NASA Electronic Parts and Packaging (NEPP) Program 2019 Electronics Technology Workshop

NEPP Program Task 19-294 Government Working Group Update

Prepared by: MSFC ES43/Jeff Martin
MSFC ES43-JSEG/Kathy Laird

June 2019

FIGURE 2012-7. Lid seal voids and rejection criterion.

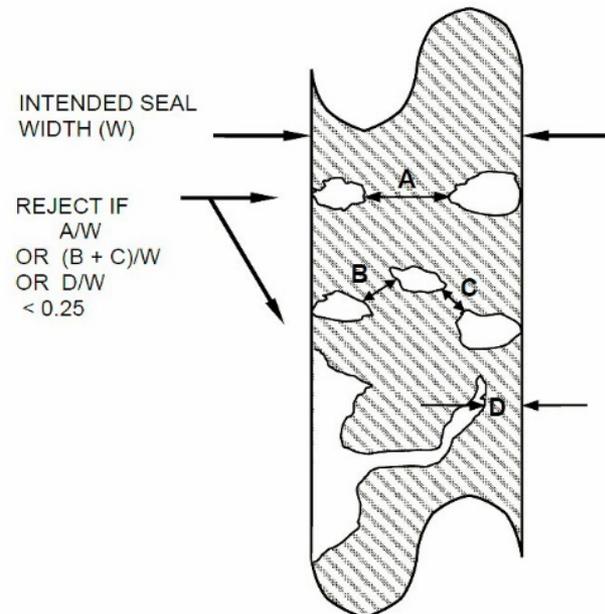
- **In the 2017/2018 timeframe, GWG developed a unified stance disapproving two JEDEC Task Group 15-02 X-Ray Seal Voids proposals to change MIL-STD-883 TM2012 lid seal void requirements.**
 - **Initial Proposal: Increase voiding criteria from 75% to 95%**
 - ❑ A GWG consensus objection letter signed by NASA, US Air Force (SMC/AFMC), Navy, and Army representatives was sent to DLA
 - **Second Proposal: Inclusion of fillet in the intended seal width**
 - ❑ Two GWG opposition presentations were given by Kathy Laird/NASA-JSEG and Matt Dorcon/NSWC Crane at the JEDEC JC13 Task Group 15-02 X-Ray Seal Voids Meeting in January 2018.

- After the GWG presentations, it was agreed by the JEDEC task group in January 2018 that the inclusion of the fillet as part of the intended seal width would not be added to MIL-STD-883 TM2012 due to the fact that:

- The formation of the fillet is not a design feature of the seal process. Fillets form when solder flows out from under the lid during the seal process.

- In most if not all cases, the fillet width by itself would meet the 25% required seal width.
- The GWG also recommended the fillet allowance stated in MIL-STD-750 TM2076 be removed. This allowance will be removed in the next draft.

FIGURE 2076-7. Design sealing width and seal fillet graphic.

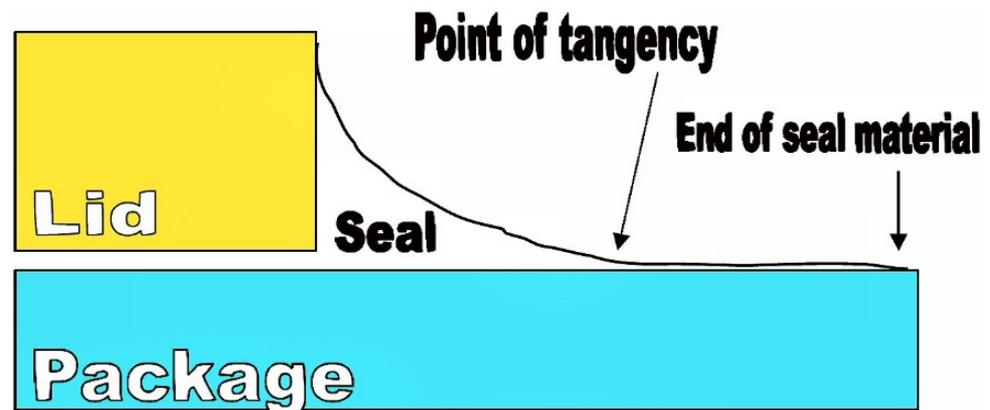
• Justification Not to Allow Inclusion of Fillet in Intended Lid Seal Width

- DLA Land and Maritime has no history of why fillet was included in the seal width for MIL-STD-750 product (requirement inserted in TM2076 in 1/3/2012)
 - M750 has significantly tighter leak rates than M883 and some believe the fillet inclusion was a compromise since tighter leak rates and this change were made in the same timeframe.
- The fillet is not a design feature of the seal process.
 - Fillet width is not a controlled process.
 - Fillet forms when solder flows out from under the lid during the sealing process, and tapering of the fillet results in a non-uniform seal width (see figures on Slide 8).
 - Solder pullback severity can negate the seal effectiveness of the fillet.
 - Microcrack(s) not distinguished in x-rays may compromise seal integrity as they can propagate to a void area when part is placed on board or during box level and system level testing.

• Example 1: Excessive Voiding Underneath Lid

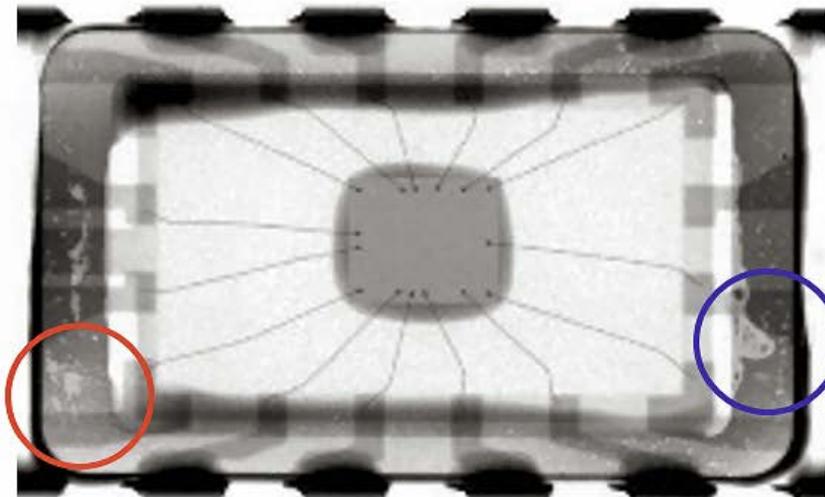
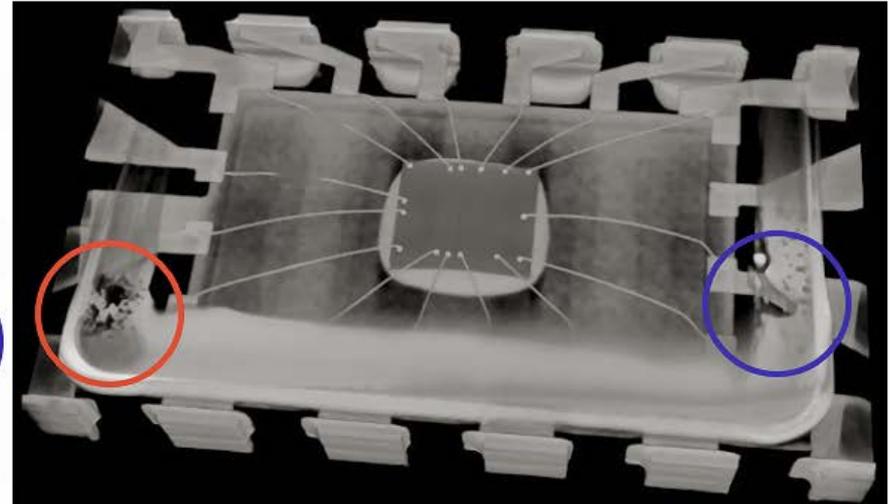
- Voids may reduce sealing width underneath the lid by more than 75% and also contact the fillet.
 - Microcrack(s), not distinguished in x-ray, may compromise seal integrity as they can propagate to a void area.
- The current lid seal requirements would fail this device, yet pass if the fillet is included in the intended seal width.

This part was a randomly selected sample and had this void issue. Because this part was randomly selected, it is highly probable that there are other parts with similar issues.

• Example 1: Excessive Voiding Underneath Lid (continued)

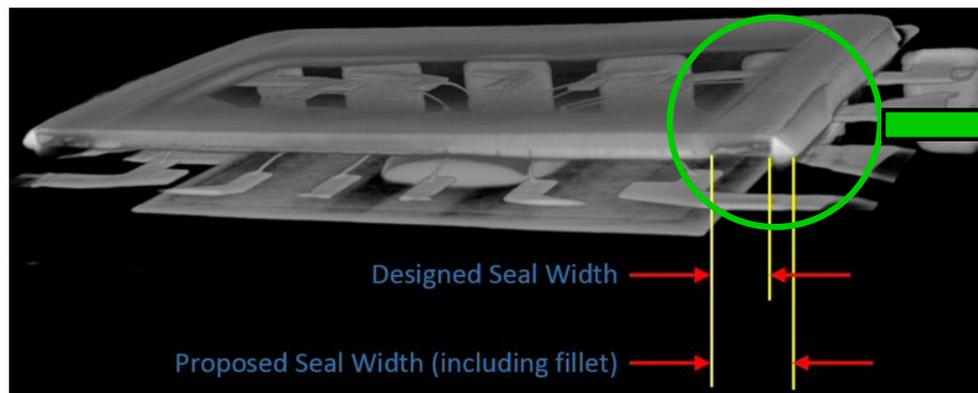
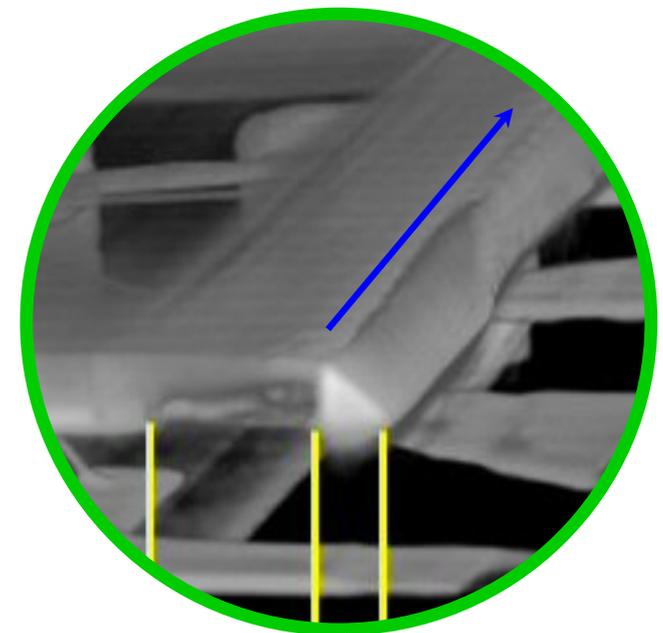
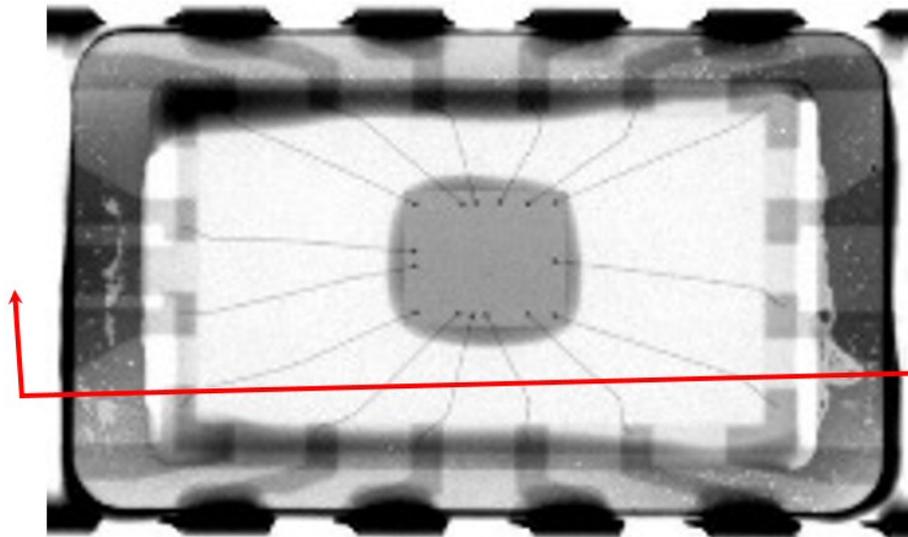
- The current lid seal requirements would fail this device, yet it would pass if the fillet is included in the intended seal width.

Darkened areas in the designed seal width are voids and the fillet width tapers (blue arrow).

• Example 2: Excessive Voiding Underneath Lid

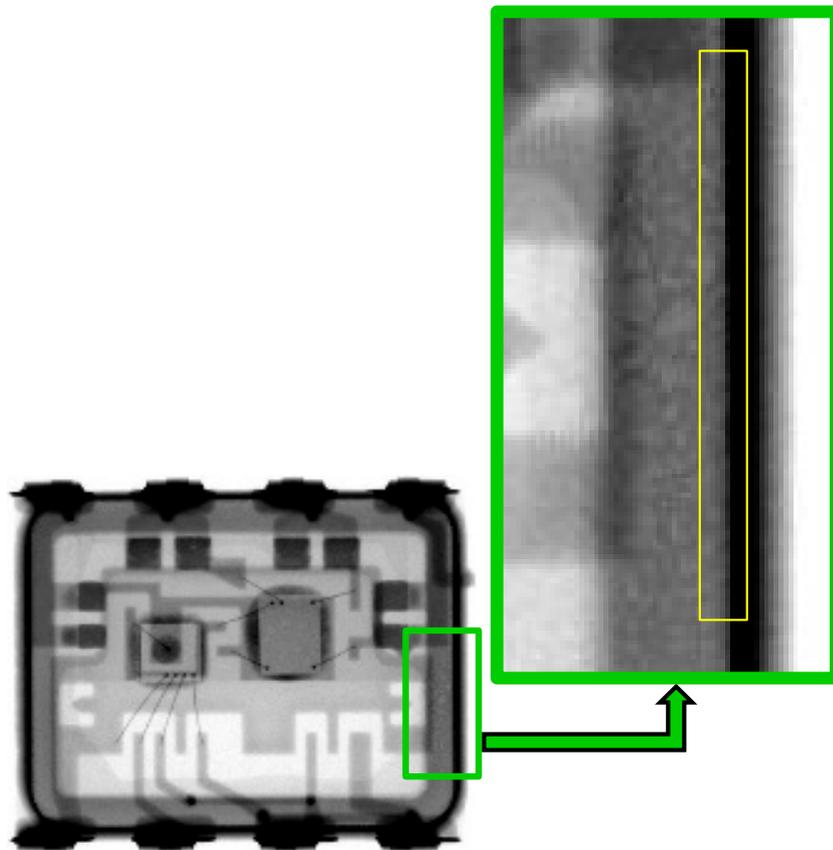
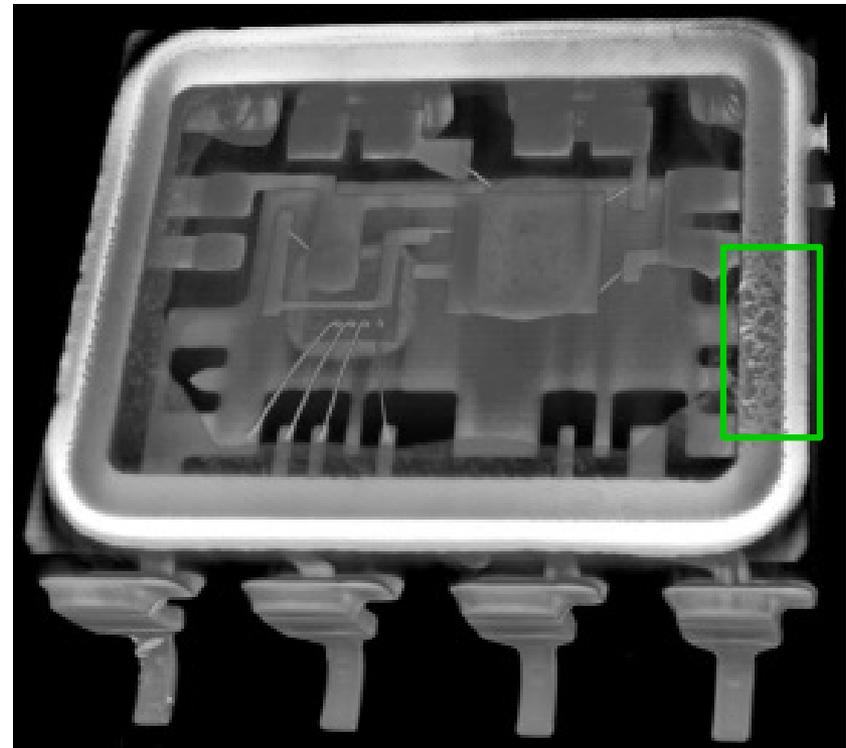
- Voids reduce sealing width underneath the lid by more than 75% and pinholes exist in fillet area next to the lid. Note that the pinholes are not clearly detected in the 2D x-ray image (yellow box) due to the thick, x-ray dense solder of the fillet.

• Example 2: Excessive Voiding Underneath Lid (continued)

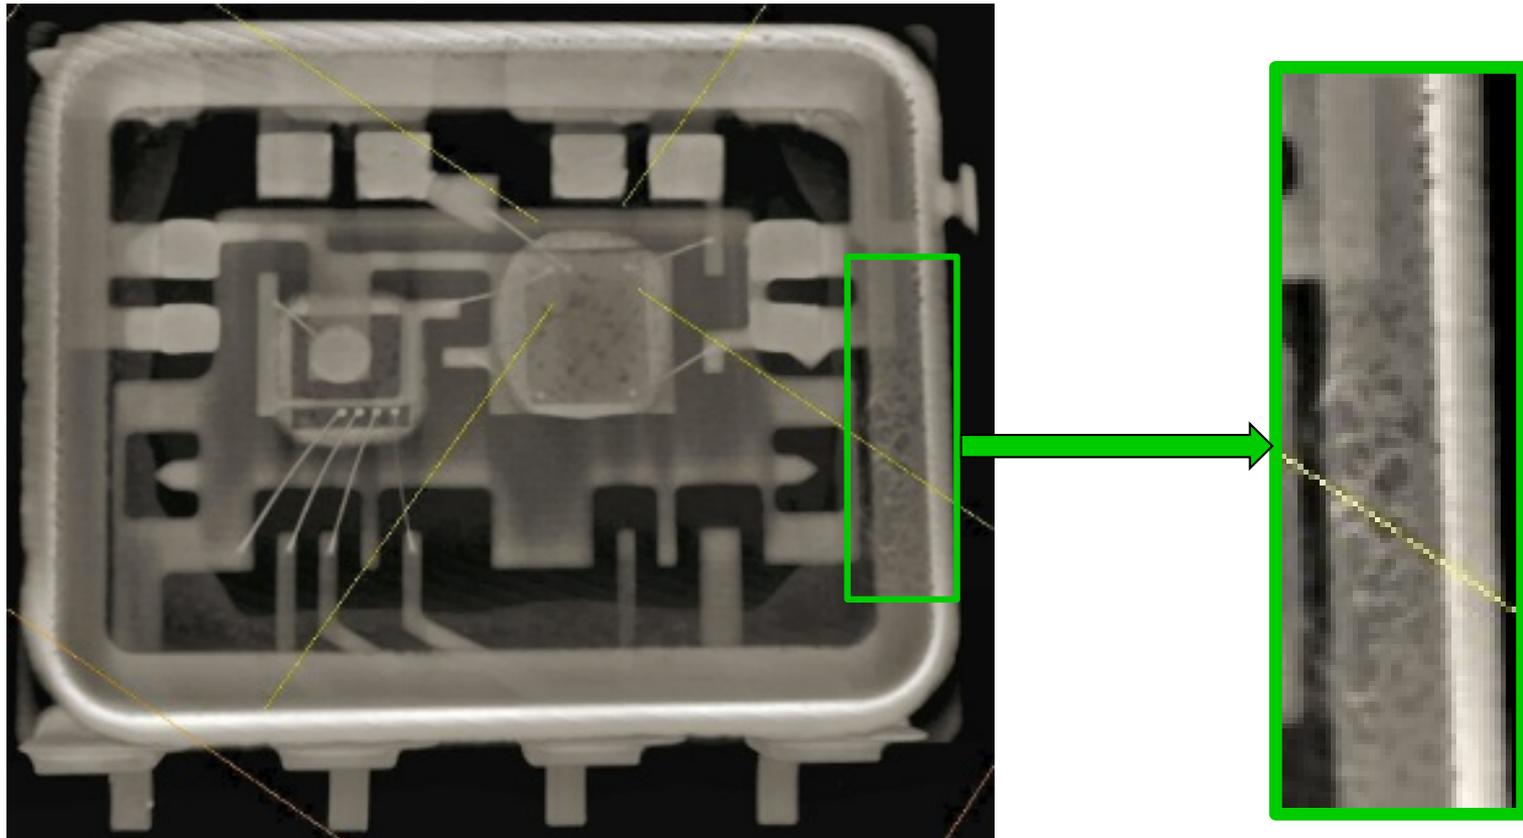
- Another 3D-CT image of the device shown on Slide 9. This part would fail the current criteria, but would pass if the fillet was included in the design width. Note the pinholes in the fillet next to the edge of the lid, which provides a potential leak path.

FIGURE 2012-5. Lid seal voids and rejection criterion.

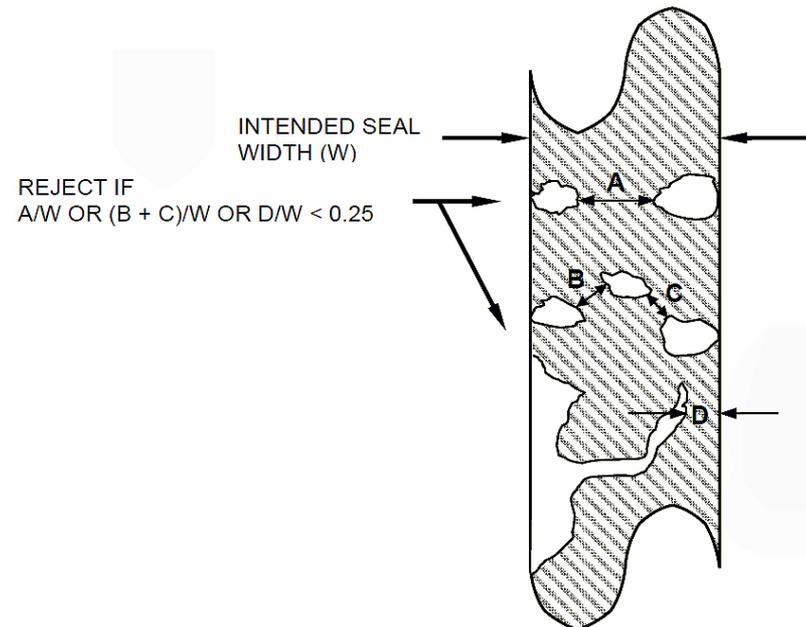
- **JEDEC Task Group proposal to change MIL-STD-883 TM2012 X-ray lid seal failure criterion.**

- Would remove “B + C” requirement and replace with seal length calculation along perpendicular line drawn from edge of package to cavity
- Would allow fillets to be part of intended seal width
- GWG does not support this change

X-ray Image of Voids

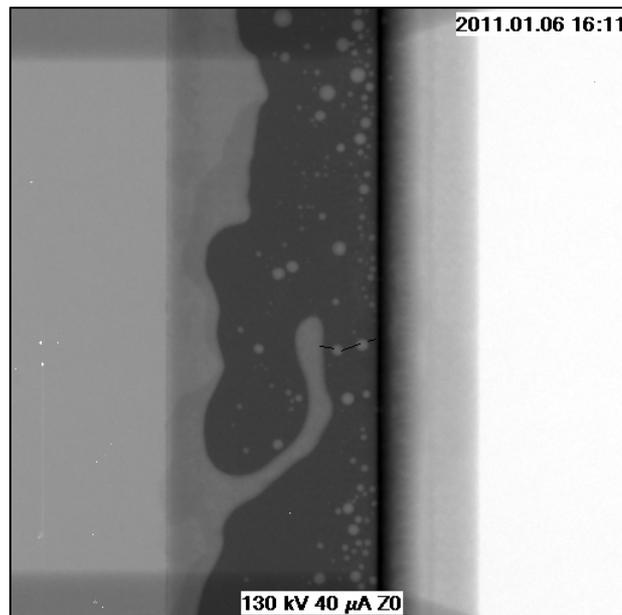
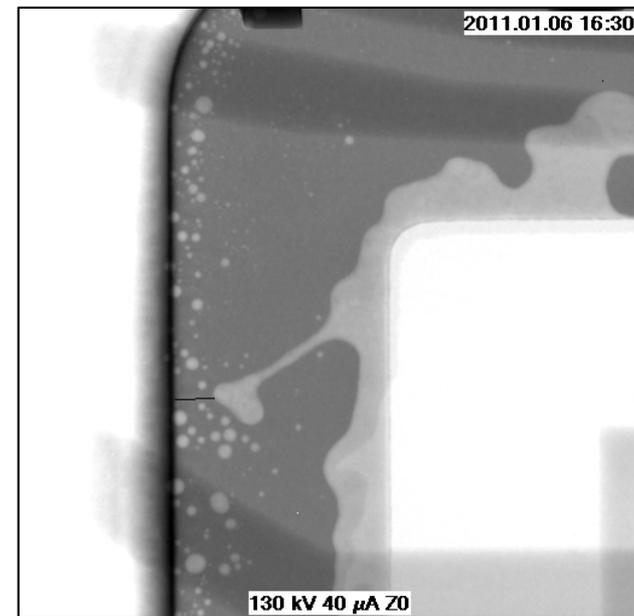
- JEDEC Task Group proposal to change MIL-STD-883 TM2012 X-ray lid seal failure criterion (cont.)
 - These microcircuits would pass the proposed criteria
